Appendix H

Highway 407 Bridge Widening Alternatives Design Brief

To:	Jeff Booker, MTO	Date:	February 24, 2017
From:	Stefan Sirianni, E.I.T., MMM Group	Job No.:	3215102 – Mavis Road EA Study
Subject:	Evaluation of Widening Alternatives for the Mavis Road / Highway 407 Crossing Structure	CC:	Frank Martins, MTO Dana Glofcheskie, Mississauga Gino Dela Cruz, Region of Peel Neil Ahmed, MMM

Figure 1: Proposed Cross-Section Design for Widened Mavis Road / 407ETR Crossing Structure

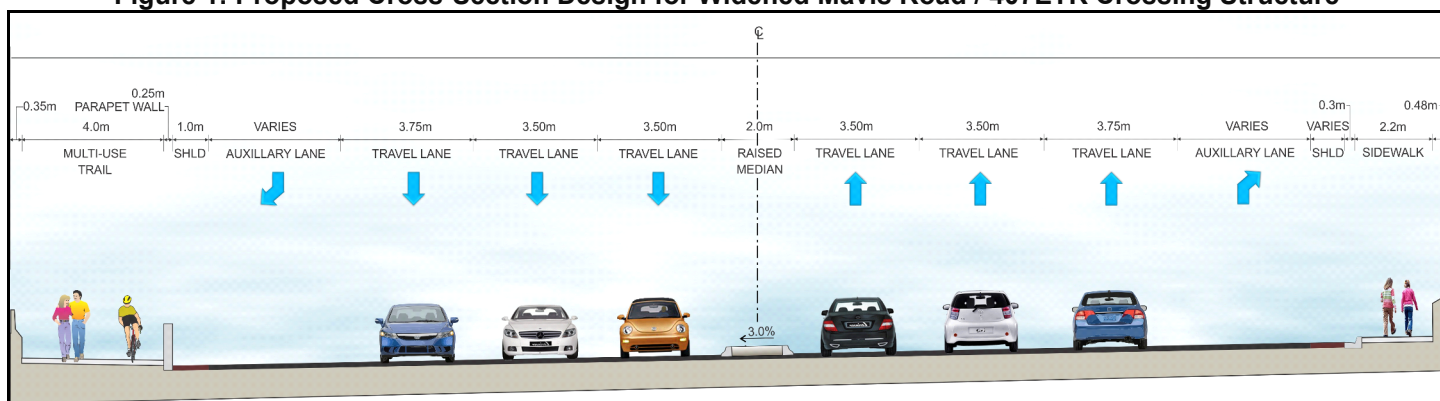
2.6	<ul style="list-style-type: none"> 407ETR noted that the proposed side clearances on the structure do not meet minimum standards of 1.5 m. MMM will revisit the plan to determine whether 1.5 m shoulders can be accommodated across the structure. <i>[Post-Meeting Note: MMM subsequently revised the plan to include 1.5 m shoulders on the crossing structure. The updated preliminary structural drawing and preliminary plan are attached to these minutes].</i>

3.3.5	MTO noted that reduction to 3.50 m travel lanes on the crossing structure would be acceptable given the proposed reduction in posted speed.	
3.3.6	MMM is to develop cross-section alternatives for 407ETR and MTO to review. The City noted that the cross-section developed for the QEW/Dixie Road crossing structure incorporates many of the same elements and may be a useful reference.	MMM

Figure 2: Preferred Alternative - Widening to the West (Alternative 1)

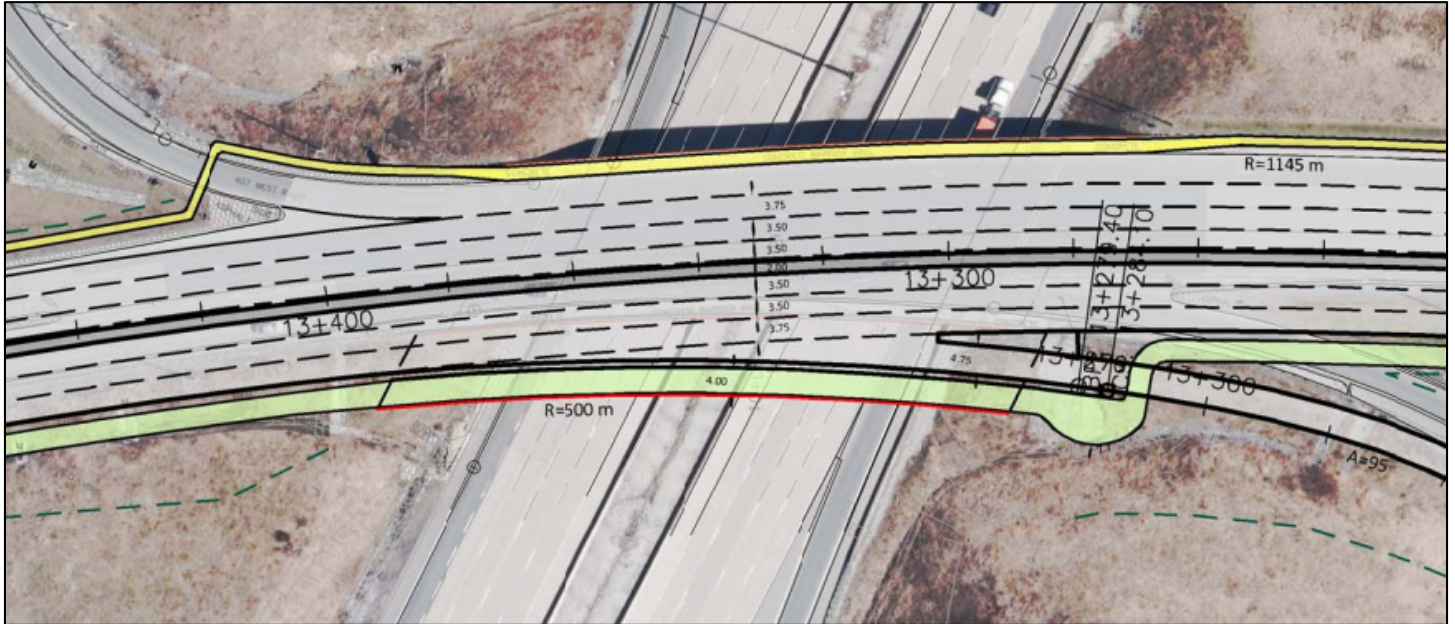
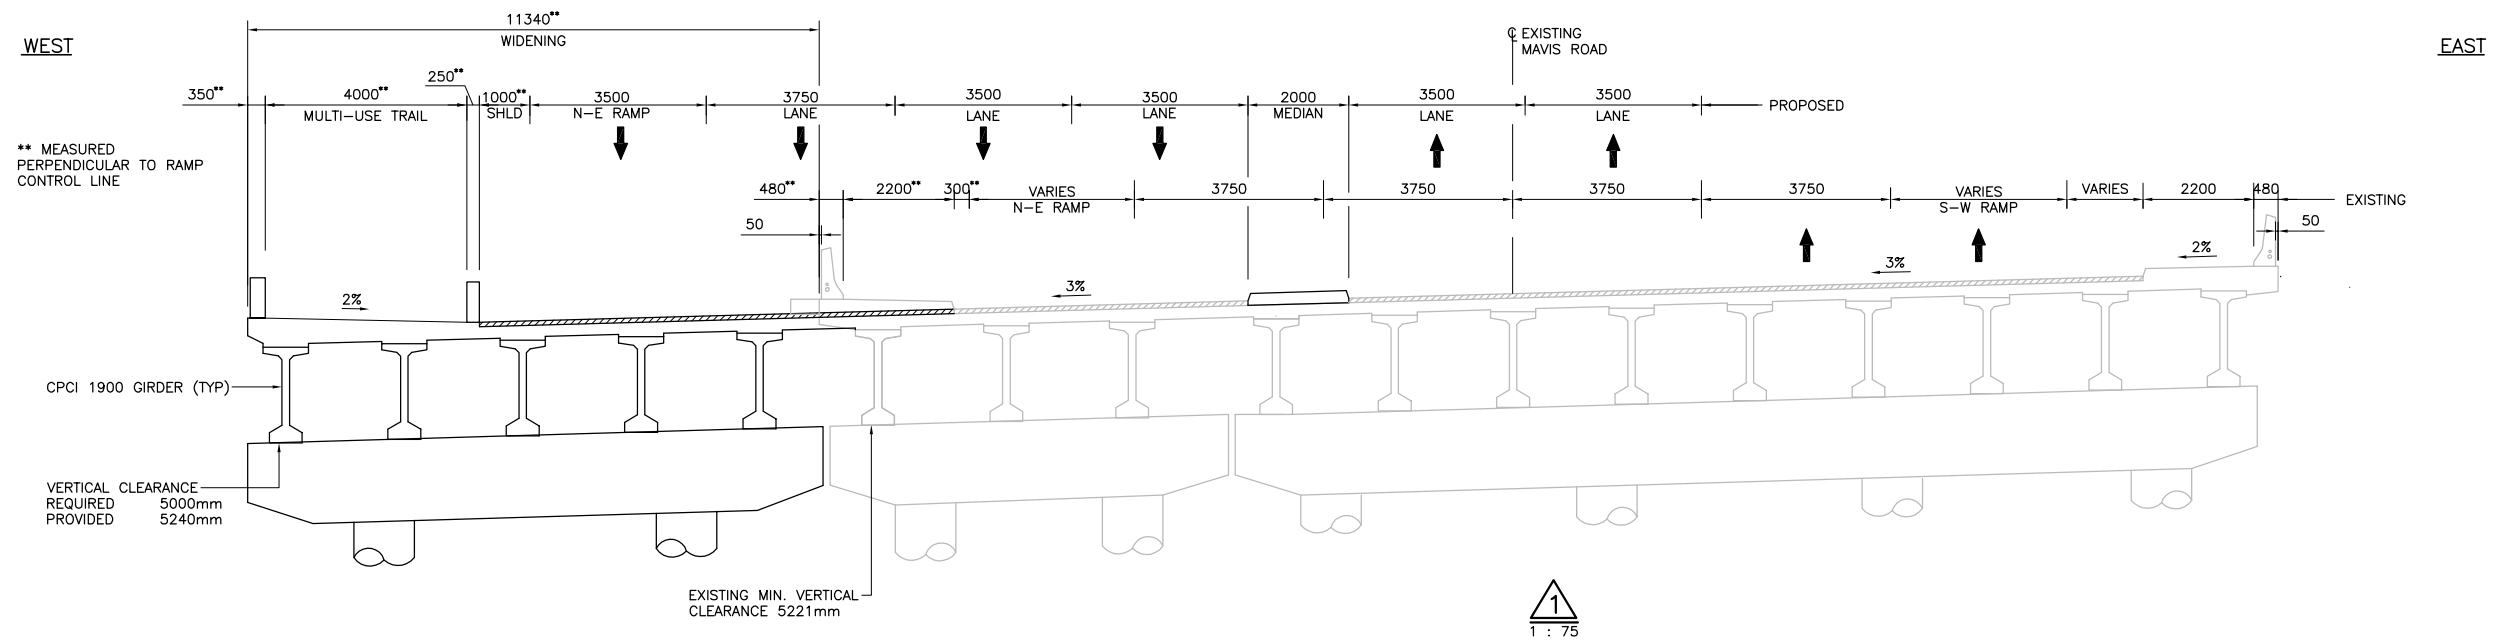
2.5	<ul style="list-style-type: none"> Overall, 407ETR and MTO confirmed they were pleased with the recommendation for widening entirely to the west. 407ETR and MTO confirmed that 3.5 m lane widths for all travel lanes would be acceptable, though Peel noted that they would prefer to maintain 3.75 m widths for the shoulder lanes if possible.

407 ETR has serious concerns with the proposed compound curve due to widening of the east side of the structure.

407 ETR prefers the structure to be widened on the Westside. 407 /MTO have just performed a bridge widening at 407/427 with clearance issues with good success. Please ensure that updates to the EA, preliminary design and cross section include an option of westside widening moving forward.

Overall, it was determined that Alternative 1, widening entirely to the west, is most preferred. As shown in Figure 2 (and in the updated preliminary plan, attached), by widening the structure by 11 m to the less constrained west side, this alternative would maintain both the existing full parallel lane and S-W on-ramp

configuration to the east, as well as required vertical clearances to the west. Realignment of the larger N-E on-ramp would instead be required, which would involve a 95 m spiral transition into the existing 85 m radius.
